STAFF REPORT
4,200 SF ADDITION TO VEHICLE SERVICE CENTER
COTTAGE GROVE CHEVROLET
SITE DESIGN REVIEW SDR 1-22
MARCH 16, 2022

Comments were received from Ron Bradsby, City of Cottage Grove Engineer on March 2, 2022. The comments are addressed in this staff report and included in the conditions of approval.

To: Eric Mongan, City Planner

COTTAGE GROVE CHEVROLET SERVICE BAY ADDITION

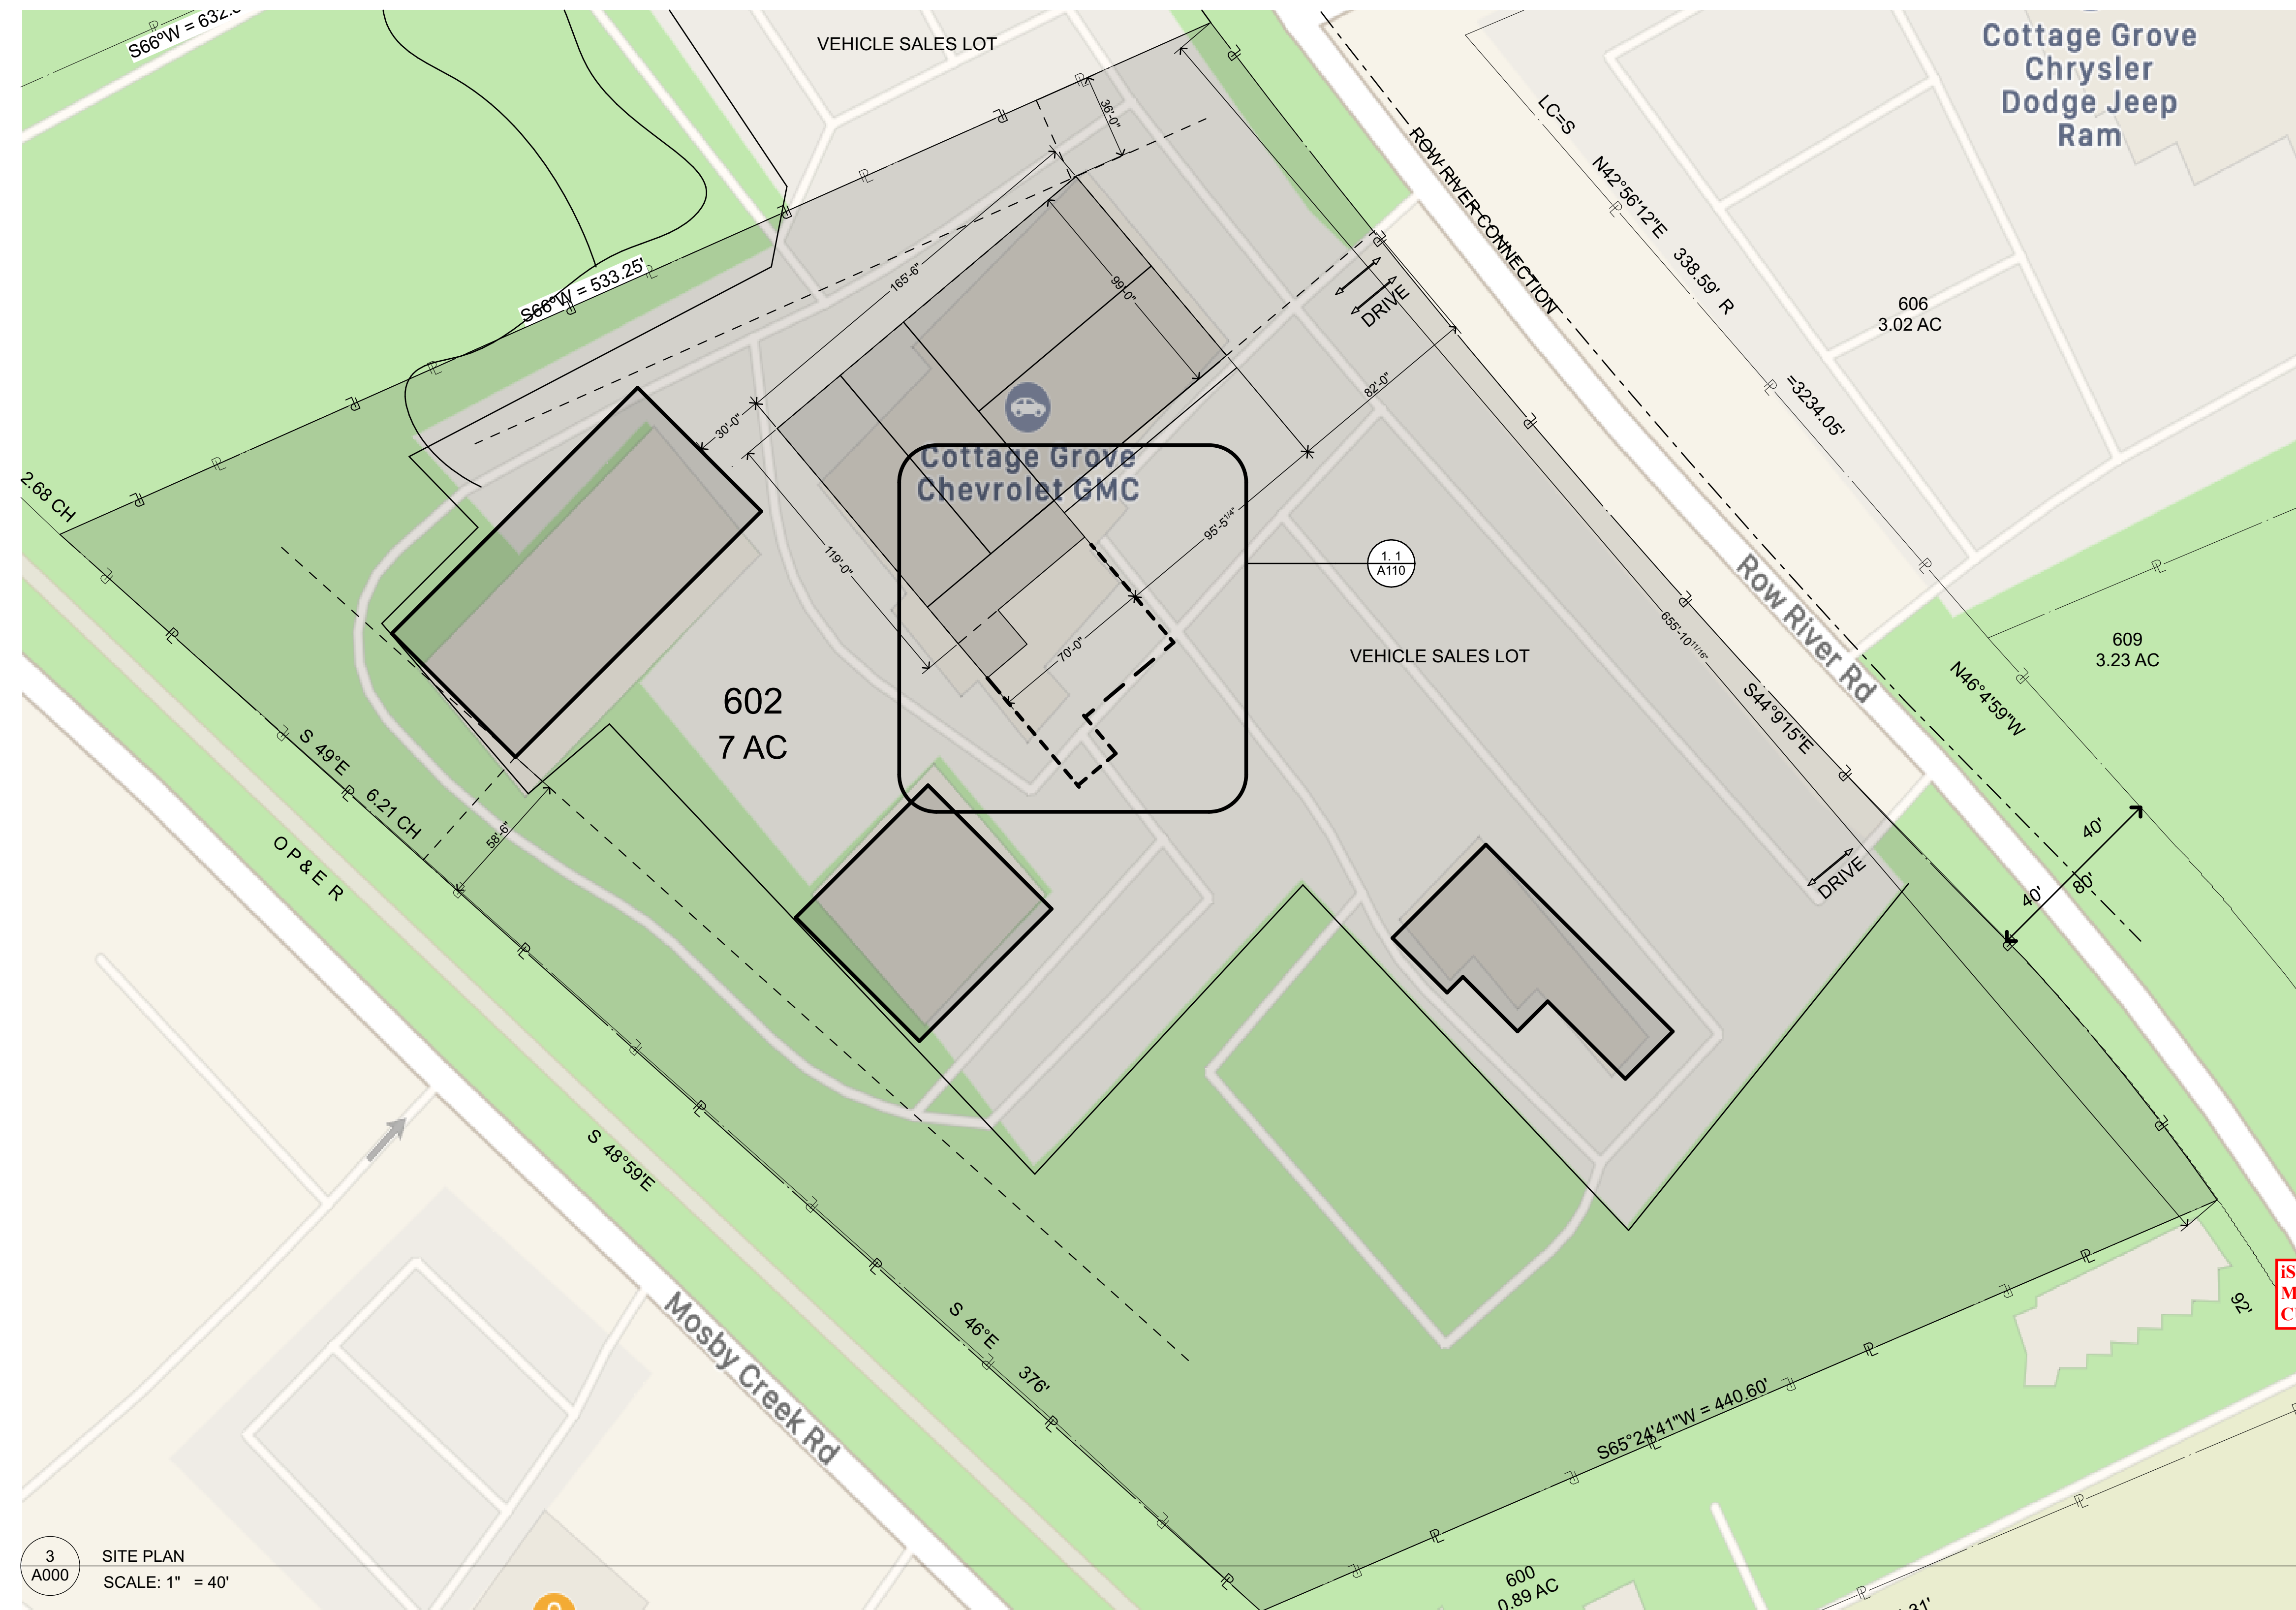
- Traffic control shall be in accordance of the Manual of Uniform Traffic Control Devices for all work performed in the public right-of-way.
- Developer will be responsible for payment of all system development charges and design review and other associated fees.
- Sheet A000 under General References states a 2009 edition. Is this the most current edition?

IS THIS THE MOST CURRENT?

BUILDING CODE SUMMARY

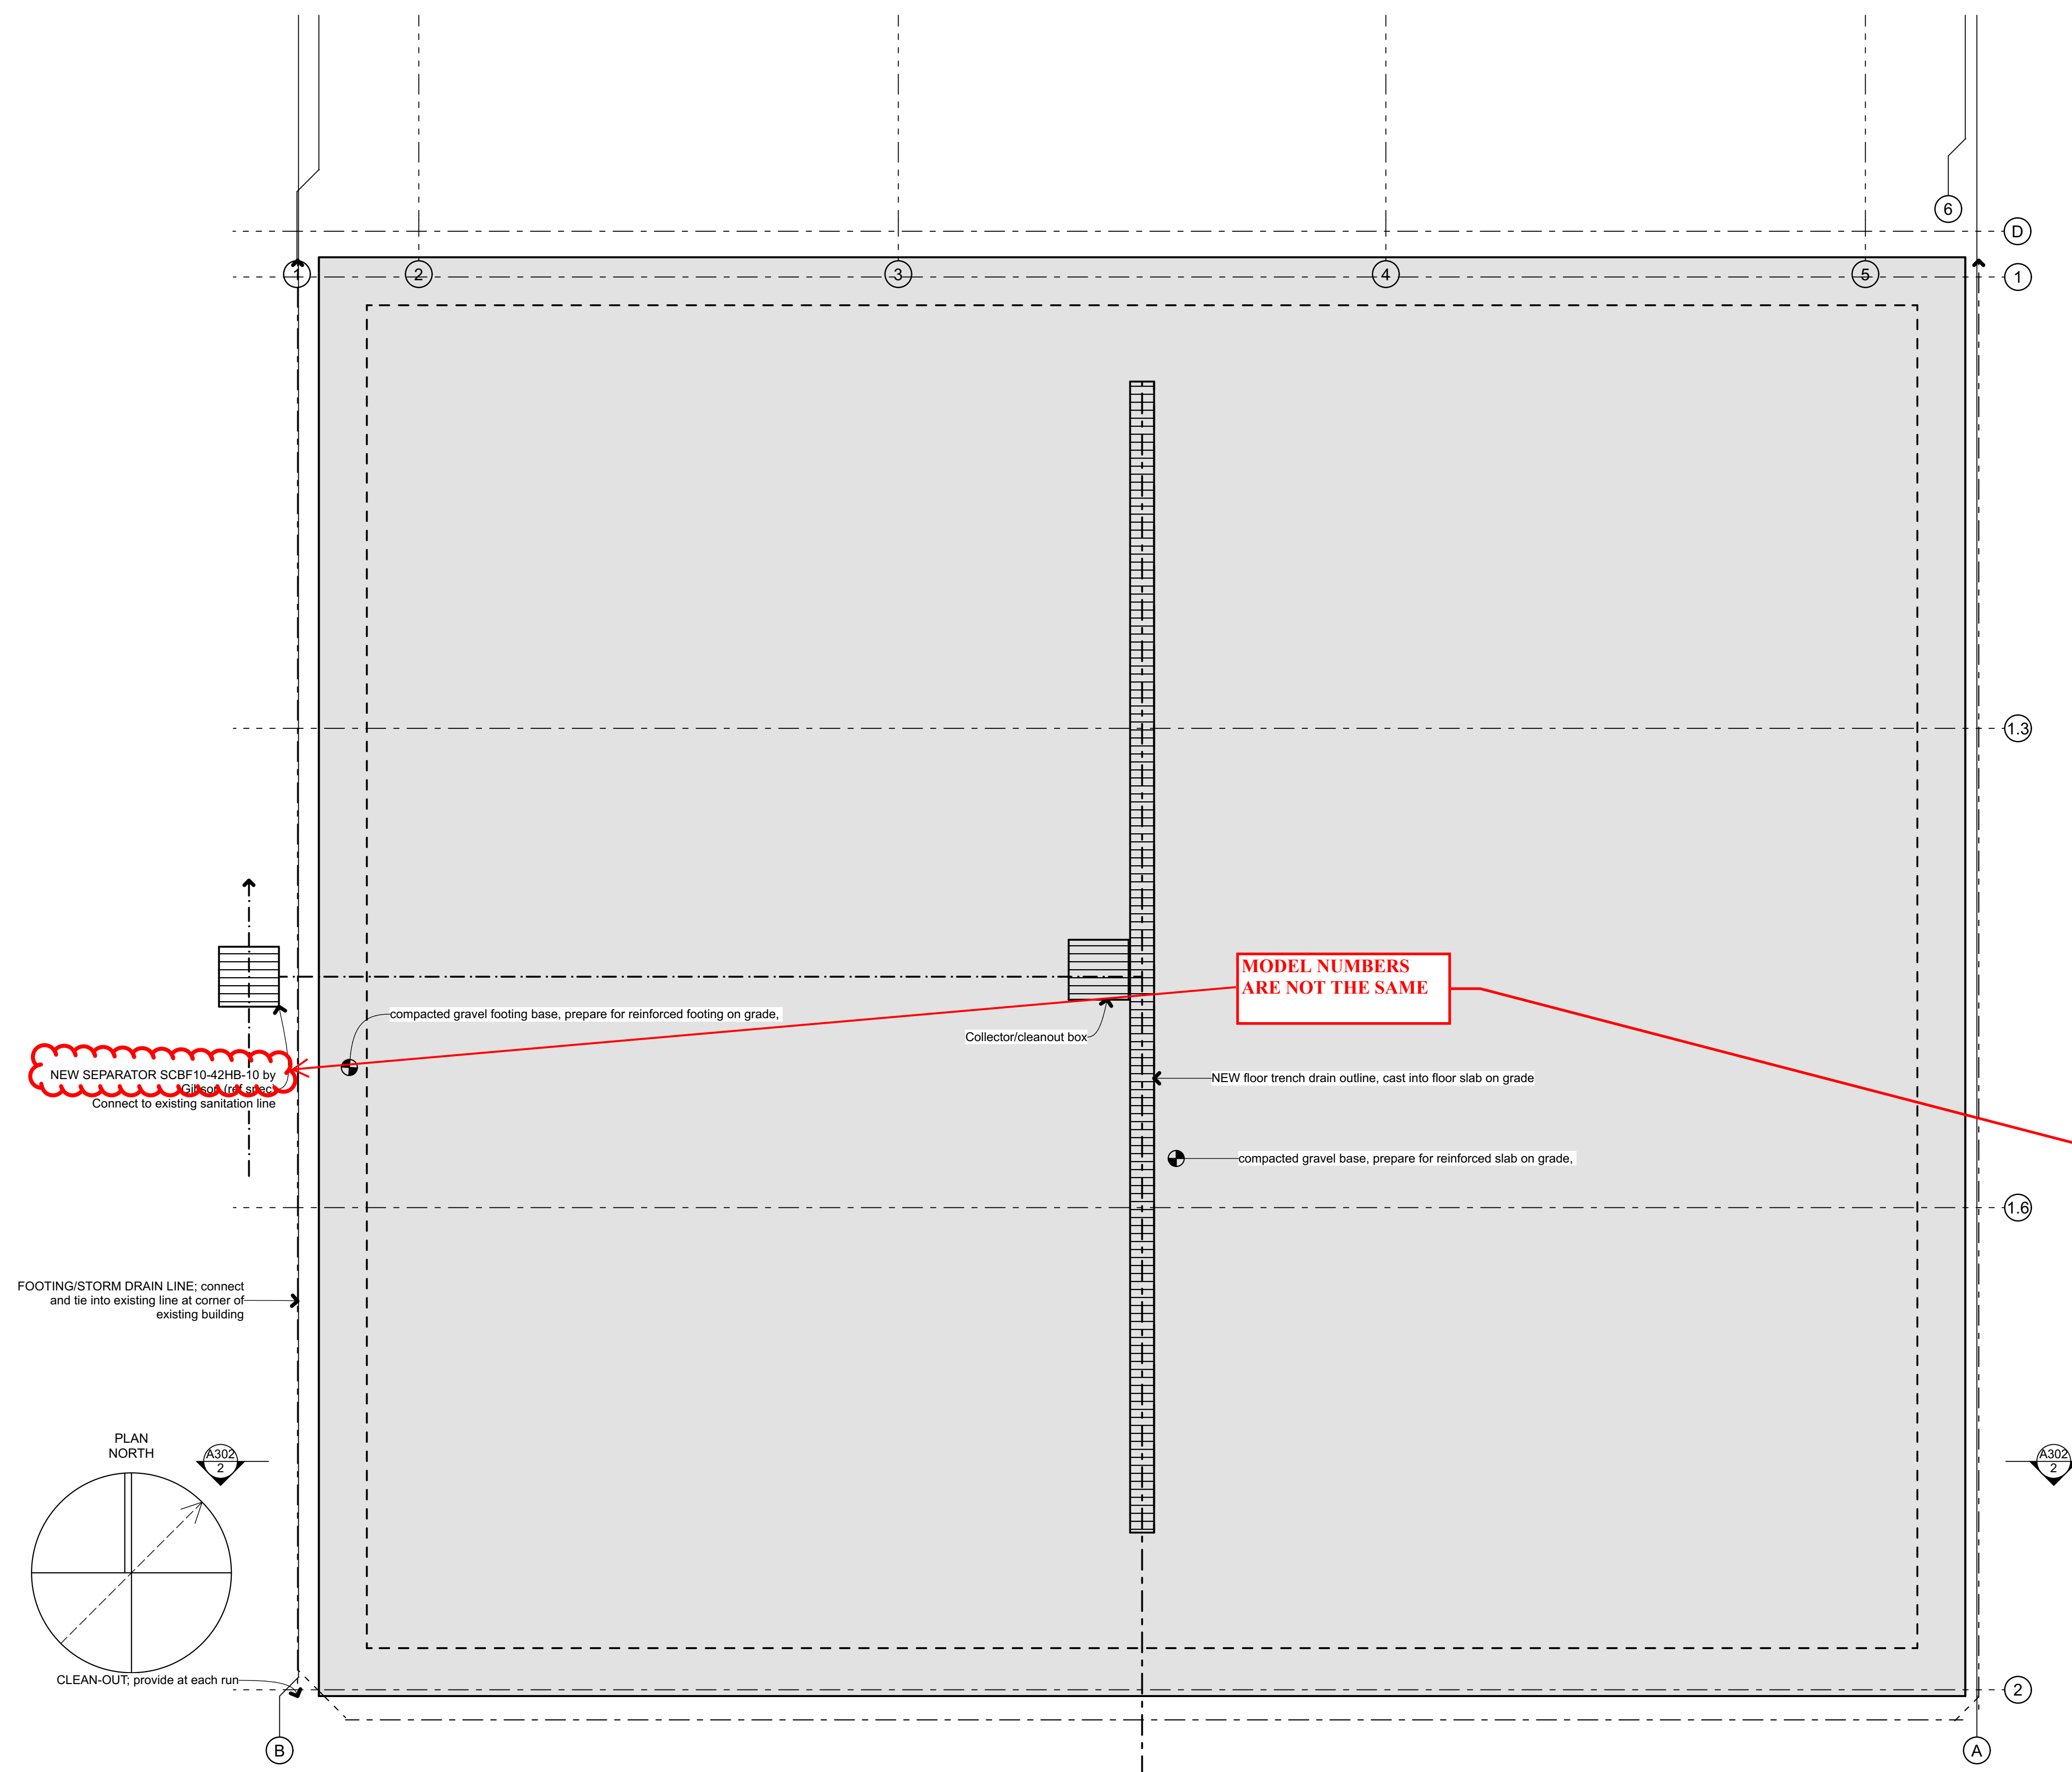
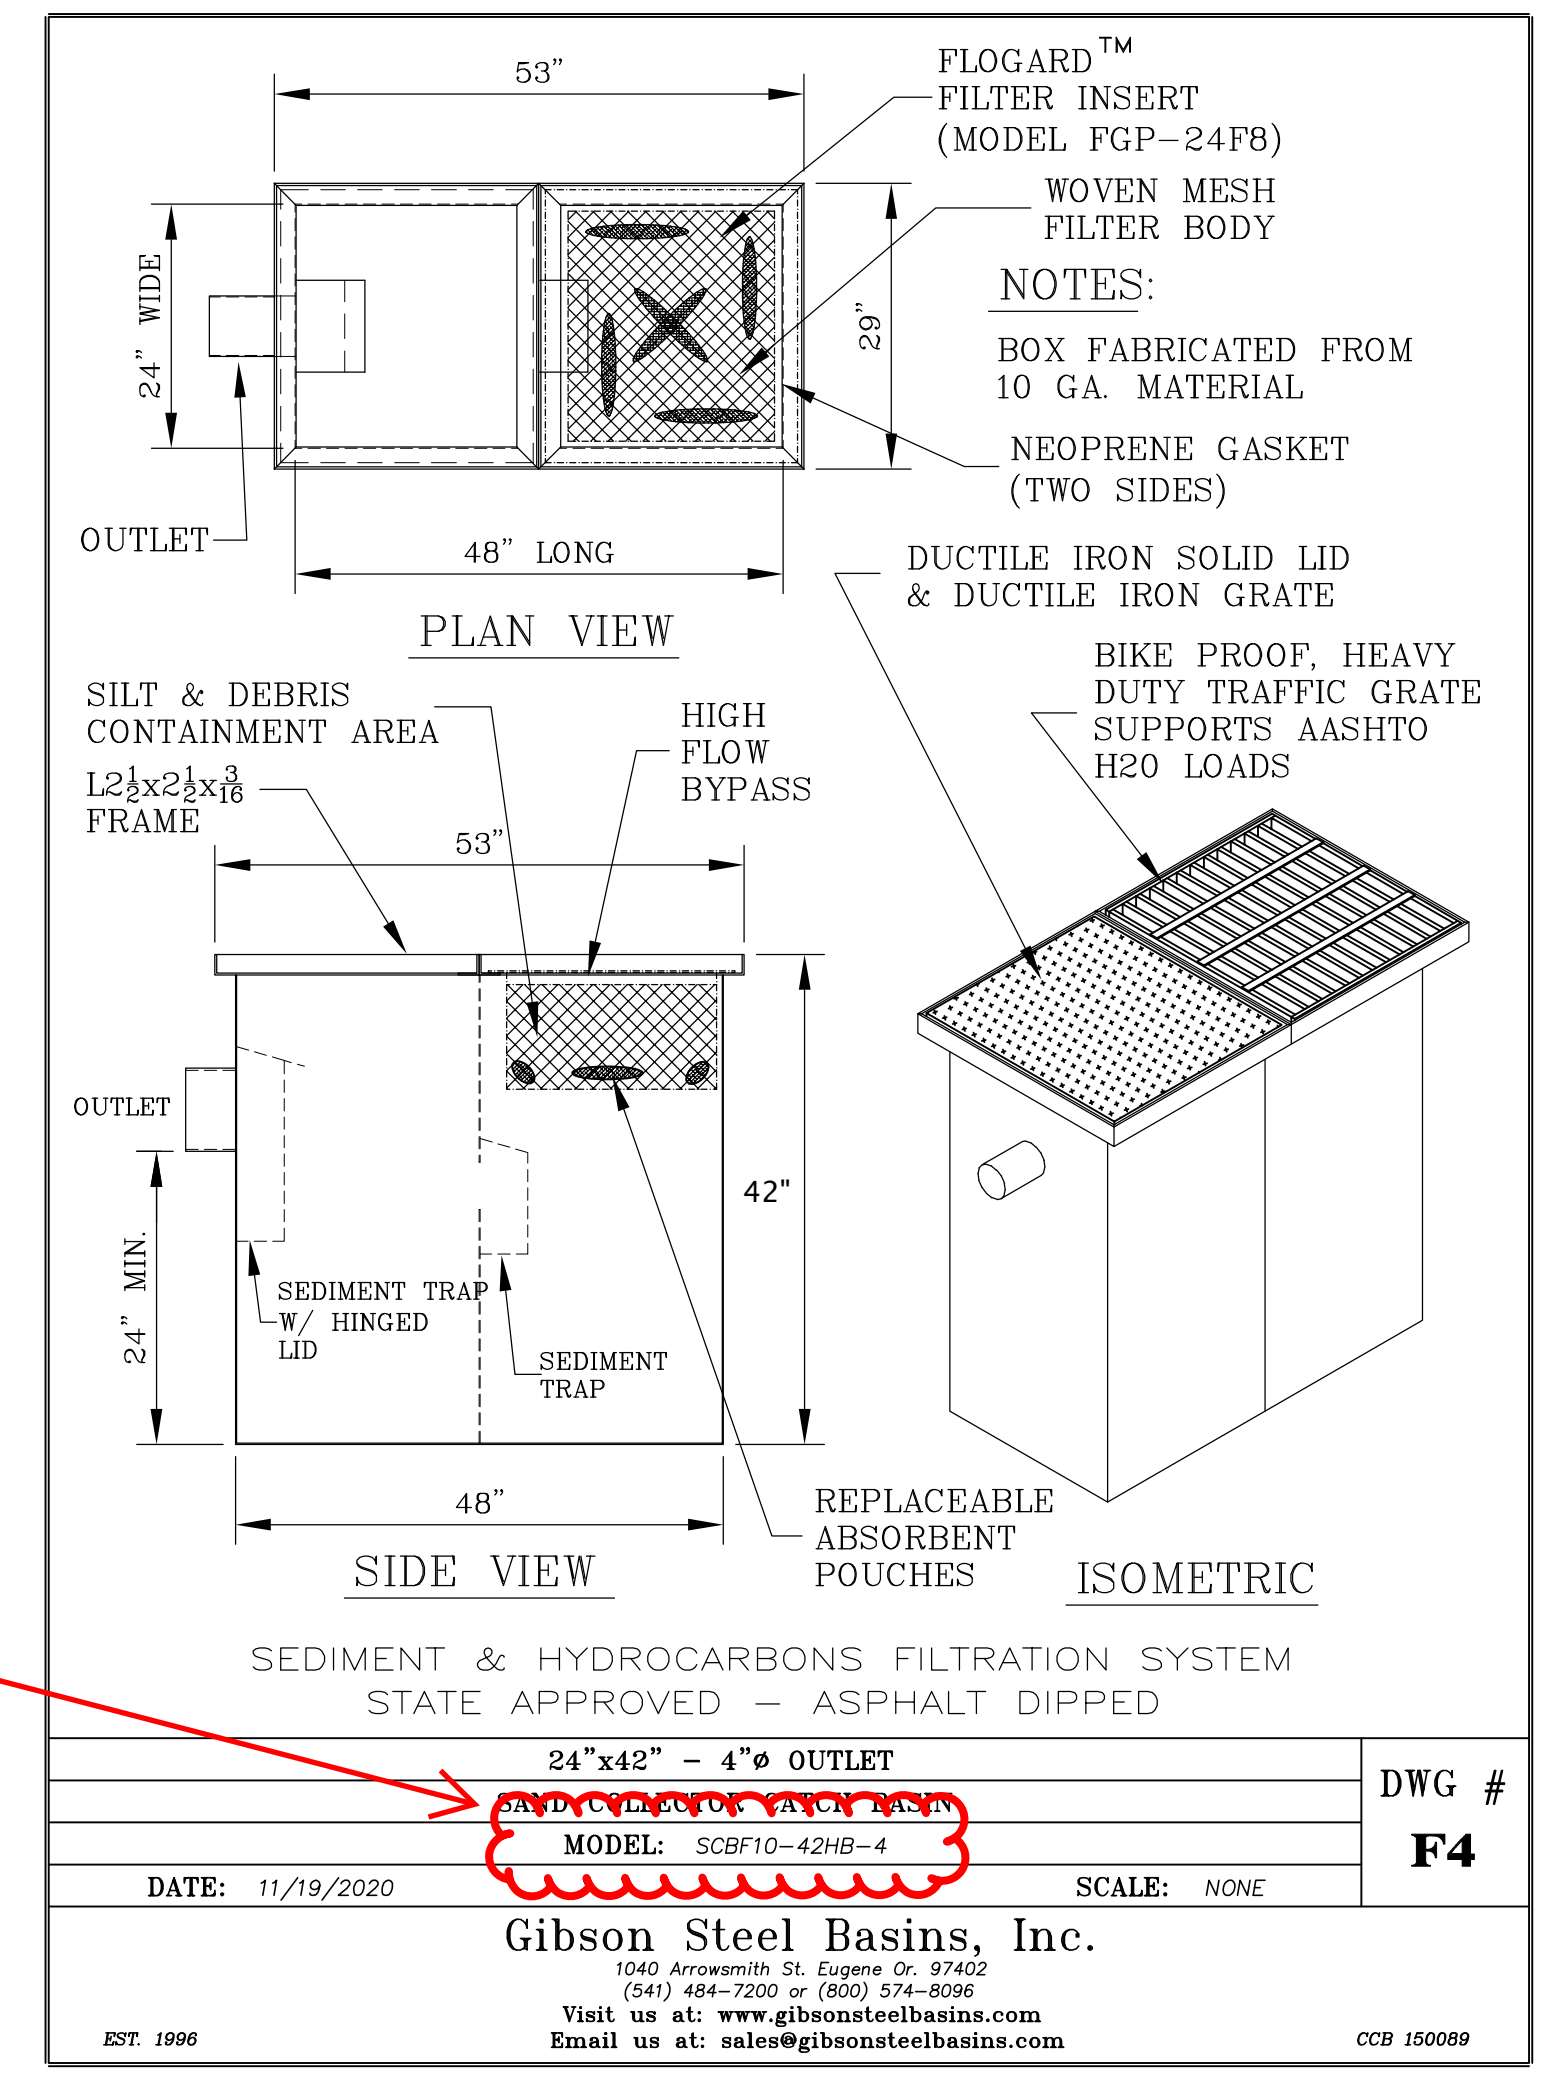
- Sheet A100 near the Building Code Summary and Design Build Notes, there is some overlapping text. On the building permit plans, it would be nice if this was corrected.
- Sheet A105 – The model number on the separator note does not match the model number in the detail. Please correct.

CLEAN UP SO THERE IS NO OVERLAP
